COMMONWEALTH OF KENTUCKY  
TRANSPORTATION CABINET  
[www.transportation.ky.gov/](http://www.transportation.ky.gov/)

CALL NO. 364  
CONTRACT ID NO. 224313  
ADDENDUM # 1

Subject: Jefferson County, FD04 056 031E 014-016  
Letting May 26, 2022

- (1) Revised - Detail Sheets - Pages 51-54 of 117
- (2) Revised - Special Notes - Pages 56-57 of 117
- (3) Revised - Sheet - R108 - Page 72 of 117
- (4) Revised - Proposal Bid Items - Pages 116-117 of 117

ITEM NO. 05-00000000  
SHEET NO. R018

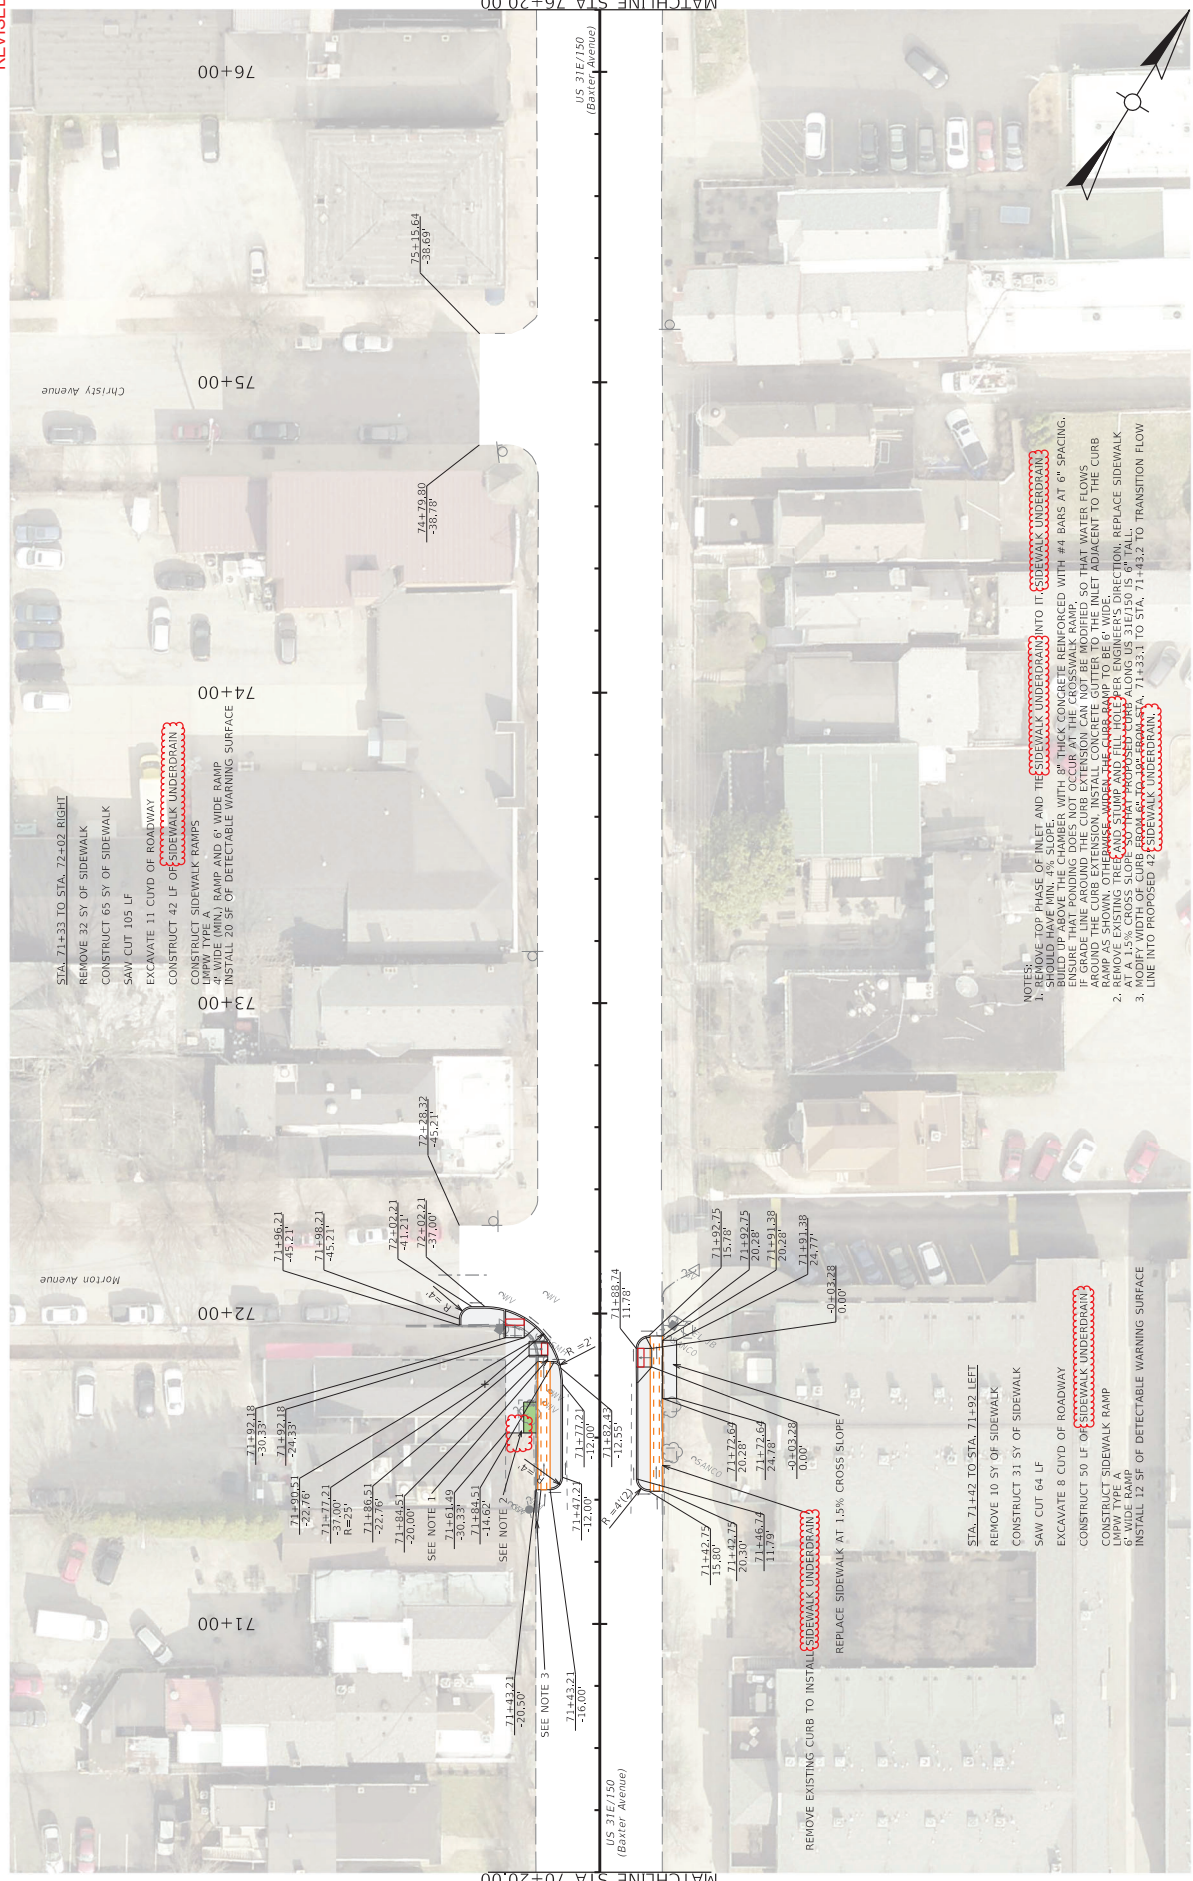
REVISED 5/16/2024

STA 71+33 TO STA 72+02 RIGHT  
REMOVE 32 SY OF SIDEWALK  
CONSTRUCT 65 SY OF SIDEWALK  
SAW CUT 105 LF  
EXCAVATE 11 CUYD OF ROADWAY  
CONSTRUCT 42 LF OF SIDEWALK UNDERDRAIN  
LAMPY TYPE A  
INSTALL 20 SF OF DETECTABLE WARNING SURFACE

STA 71+42 TO STA 71+92 LEFT  
REMOVE 10 SY OF SIDEWALK  
CONSTRUCT 31 SY OF SIDEWALK  
SAW CUT 64 LF  
EXCAVATE 8 CUYD OF ROADWAY  
CONSTRUCT 50 LF OF SIDEWALK UNDERDRAIN  
LAMPY TYPE A  
INSTALL 12 SF OF DETECTABLE WARNING SURFACE

NOTES:  
1. REMOVE TOP PHASE OF INLET AND THE SIDEWALK UNDERDRAIN INTO IT SIDEWALK UNDERDRAIN SHOULD HAVE MIN. 4% SLOPE WITH 6" THICK CONCRETE REINFORCED WITH #4 BARS AT 6" SPACING. IF GRADE LINE AROUND THE CURB EXTENSION CAN NOT BE MODIFIED SO THAT WATER FLOWS AWAY FROM THE CURB, THE CURB EXTENSION SHOULD BE ADJACENT TO THE CURB RAMP AS SHOWN. OTHERWISE WIDEN THE CURB RAMP TO BE 6' WIDE.  
2. REMOVE EXISTING TREE AND STUMP AND FILL HOLE PER ENGINEER'S DIRECTION. REPLACE SIDEWALK UNDERDRAIN WITH NEW UNDERDRAIN. ALLOW US TO INSTALL UNDERDRAIN FROM STA 71+33.1 TO STA 71+43.2 TO TRANSITION FLOW LINE INTO PROPOSED 42' SIDEWALK UNDERDRAIN.  
3. MODIFY WIDTH OF CURB FROM 6' TO 8' TO ACCOMMODATE 42' SIDEWALK UNDERDRAIN.
